Document Review Comment Sheet

PEB Ref. No : TB2-PEB-SDC-M1B-TVI-02734

FIG. UG-118 FORM OF STAMPING

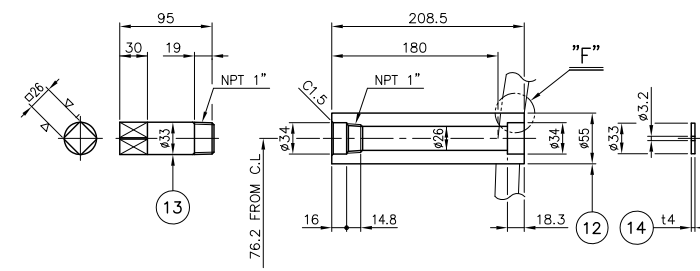
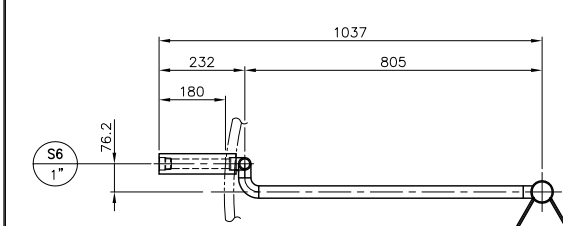
2	Please note that: Nameplates shall be in English with a minimum letter size of 6.4 mm.		ASME 'U'stamp project letter size was min 4mm.(UG-108). But we will used letter size 7mm.
